## REGION 4

**SUBJECT:** Addendum to Operable Unit 4 Feasibility Study

**FROM:** Pam Scully, Remedial Project Manager

Pharmacia LLC/Solutia Inc. (P/S) submitted a revised Operable Unit 4 Feasibility Study (OU4 FS) for the Anniston PCB Site (the Site) on May 1, 2023. The EPA reviewed the OU4 FS and used it to draft a Proposed Plan. Some information from the OU4 FS has been changed in the Proposed Plan to reflect EPA's comments and conclusions. This Technical Memorandum is intended to document significant Proposed Plan changes to the FS.

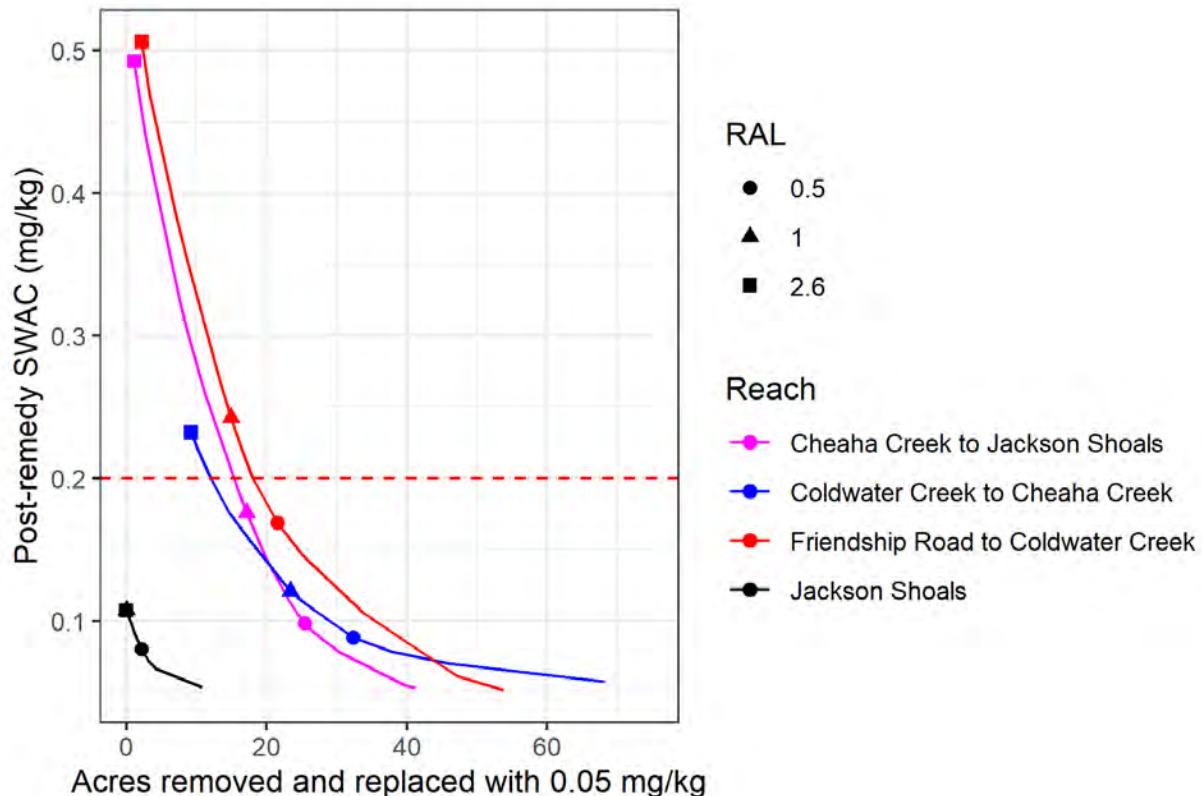
In sum, for the remedy to be protective above the Lake Logan Martin backwater, about 33 additional acres would need to be remediated (i.e., 33 acres in addition to the 12.6 already proposed). The figure below includes the RAL-SWAC relationship for all the evaluated areas. This figure demonstrates the SWACs that would result from various RALs. The shape of these curves (e.g., the “knee of the curve”) can be also used to assess when RAL reductions become less effective at reducing SWACs. It suggests that PRG attainment is still in the zone of maximum incremental risk reduction.

Overall, the analysis provides an understanding of the relationship between the remediation and PRG attainment. This information provides a more appropriate basis for selecting the remedy than considering a singular RAL without consideration of the impact on the SWAC PRG, and relying on an MNR model that does not have an appropriate basis (See 2020/2023 CSTAG comments). It also addresses the question of what a protective remedy would entail (at least based on the collected data).

Figure 1: Sediment textures with no chemical data removed from the remedy and SWAC calculations. Note the Jackson Shoals to Lake Logan Martin reach is truncated at 100 acres to enable better viewing for other reaches.

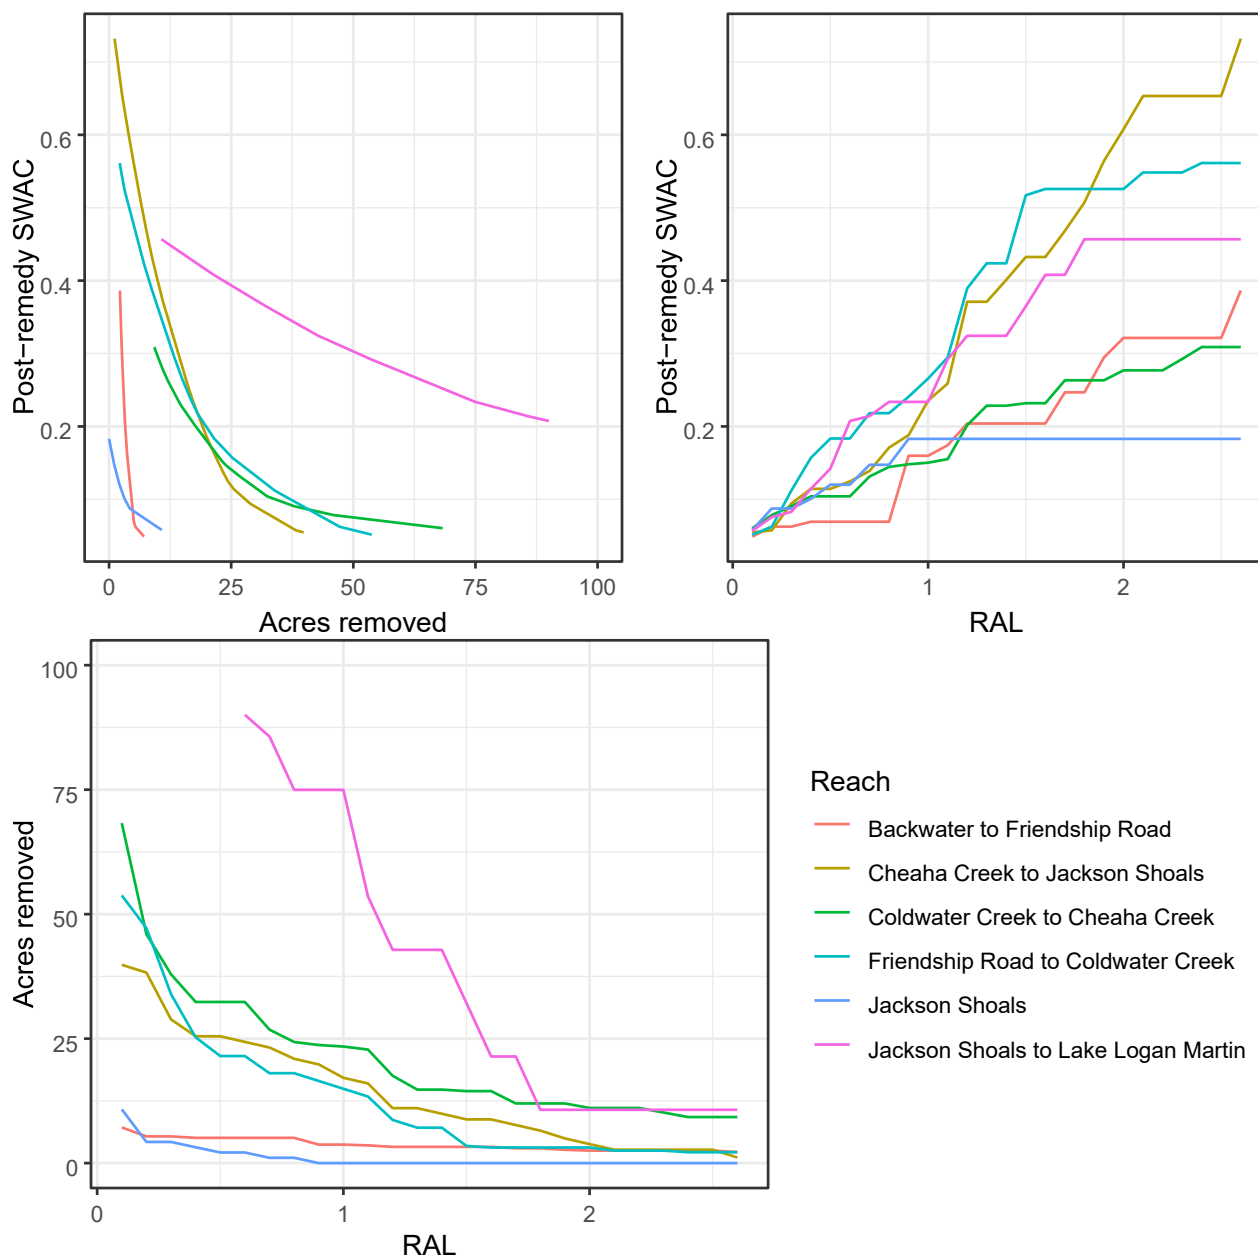
Figure 1 shows combinations of the RAL, acres removed, and post-remedy SWAC when sediment textures without any chemical data in a reach are omitted from the remedy and from the SWAC calculations. For these calculations, the replacement concentration in areas remediated in these calculations was 0.05 mg/kg.

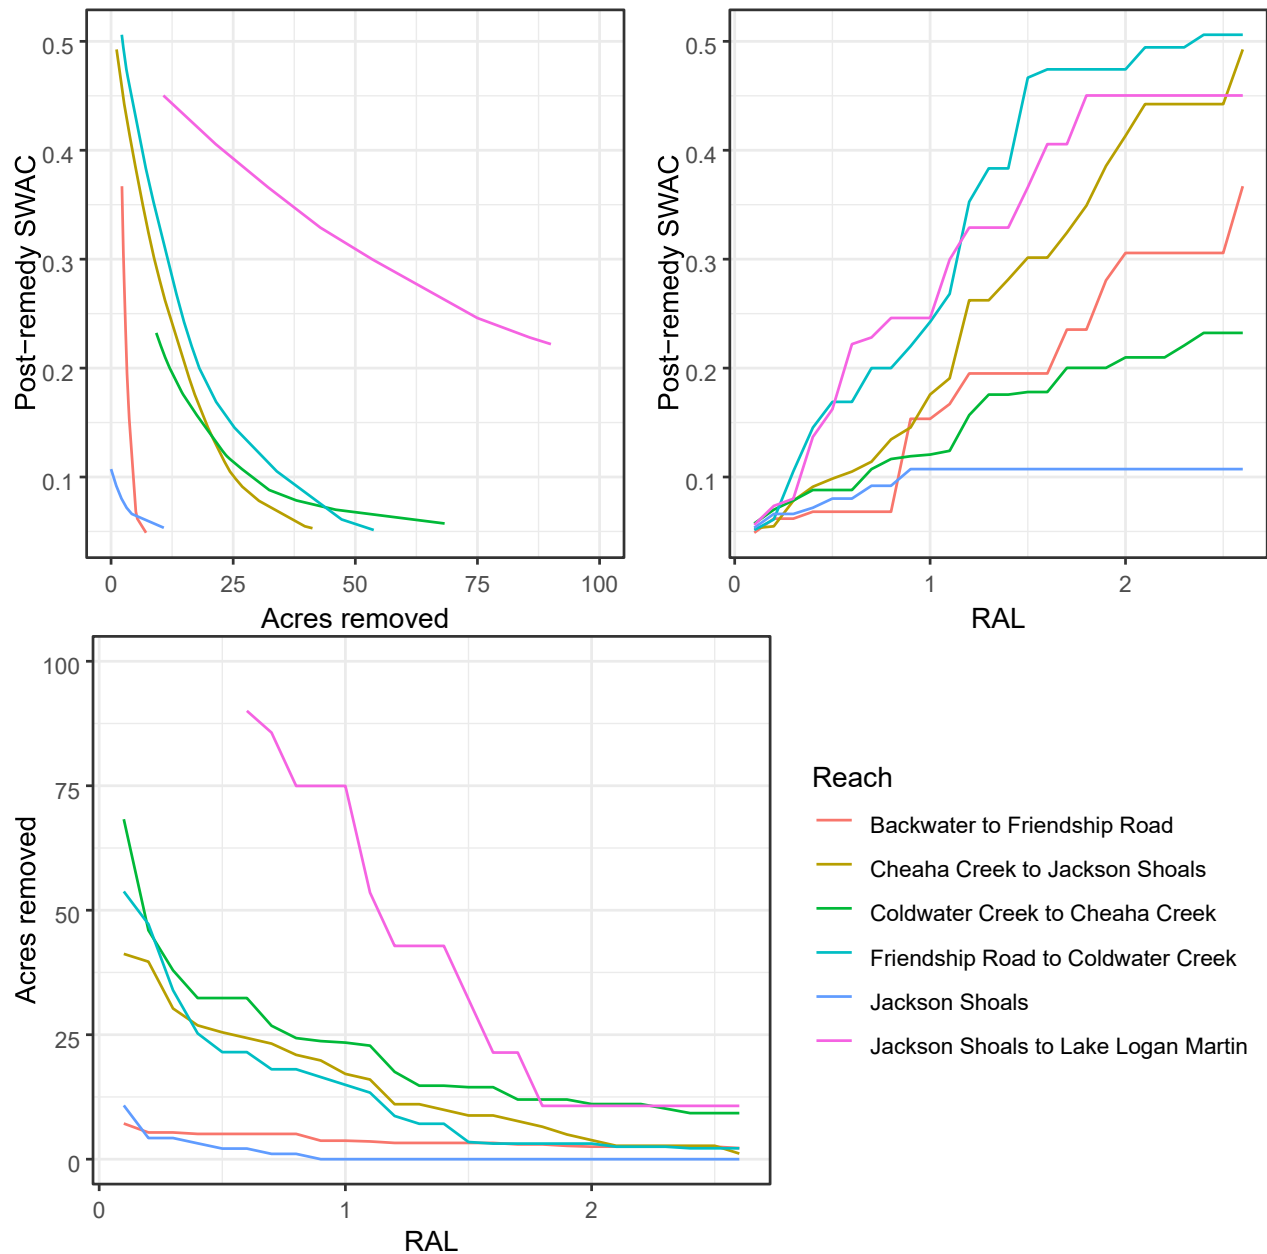
Figure 2 shows combinations of the RAL, acres removed, and post-remedy SWAC when Solutia's assumptions are used to calculate the SWAC: areas of no recovery are assigned a value of 0.05 mg/kg, and gravel areas where no samples were taken are assigned the respective average concentration of the coarse samples within the reach. Scenario 2 would require less surface area be remediated upstream of Jackson Shoals than Scenario 1 to reach the long-term SWAC goal of 0.2 mg/kg. The total surface area to be remediated under this scenario is 49.31 acres. A summary of the required RALs to reach the long-term protectiveness is given in Table 4.

Figure 3: Sediment textures where no samples were collected are assigned a value of 0.05 mg/kg. Note the Jackson Shoals to Lake Logan Martin reach is truncated at 100 acres to enable better viewing for other reaches.

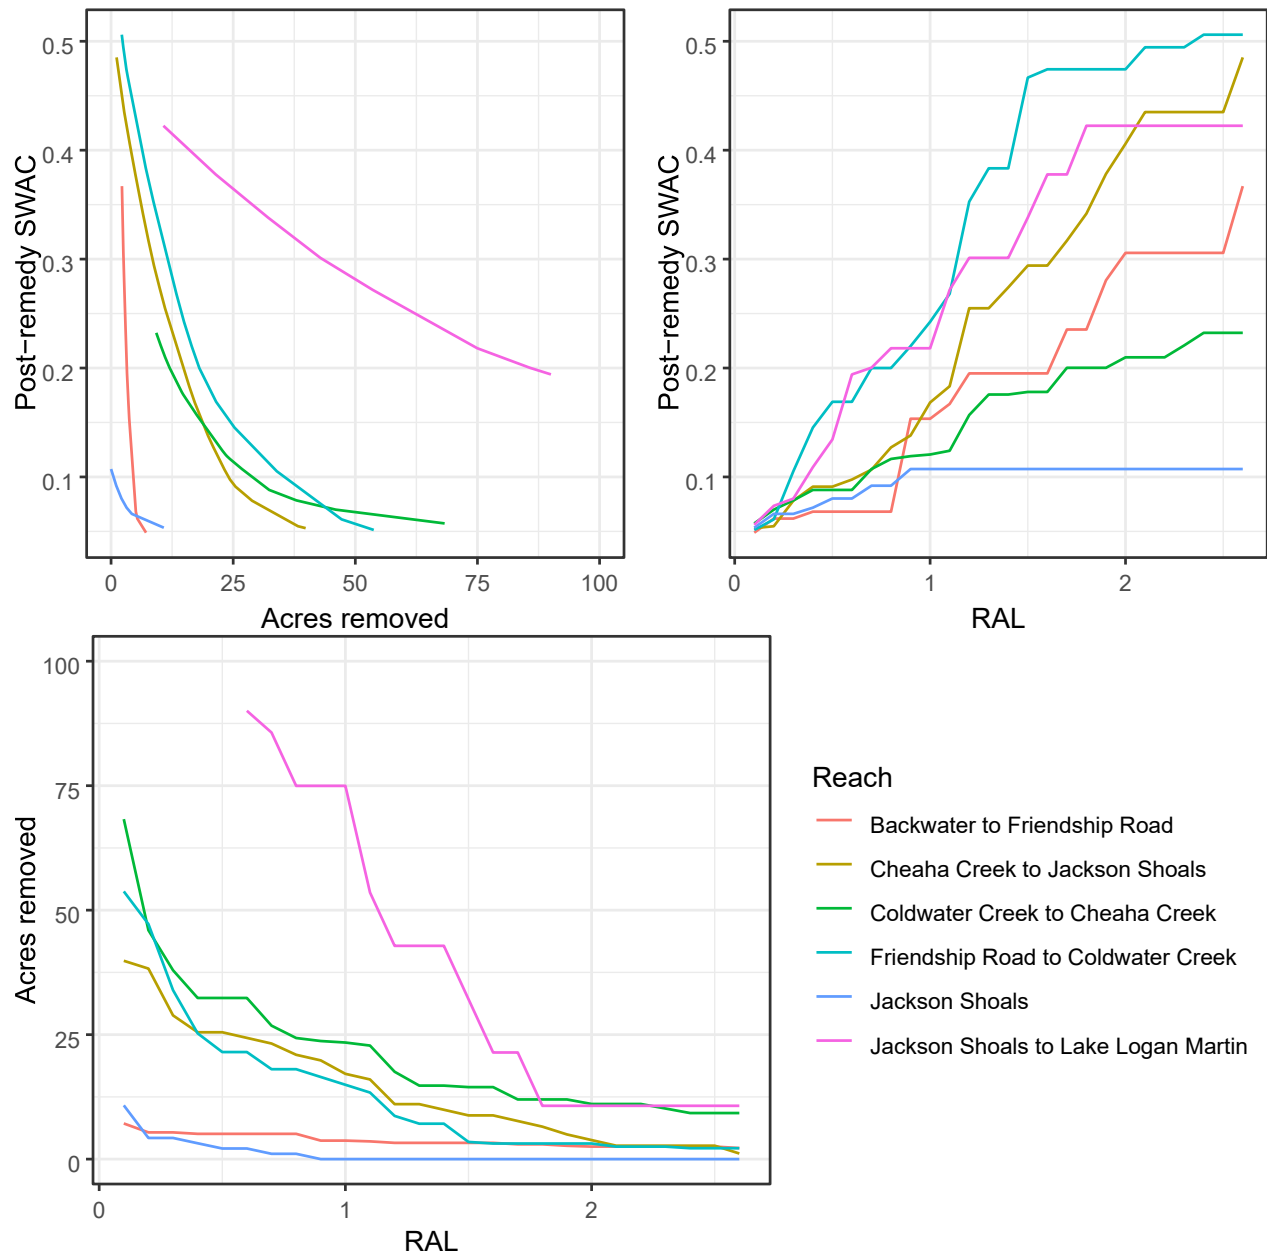
Figure 3 shows combinations of the RAL, acres removed, and post-remedy SWAC when areas of no recovery and the gravel areas where no samples were taken are assigned a value of 0.05 mg/kg. This scenario is expected to be the least conservative set of assumptions. Scenario 3 would require the same surface area to be remediated as Scenario 2 to reach the long-term SWAC goal of 0.2 mg/kg. A summary of the required RALs to reach the long-term protectiveness is given in Table 5.
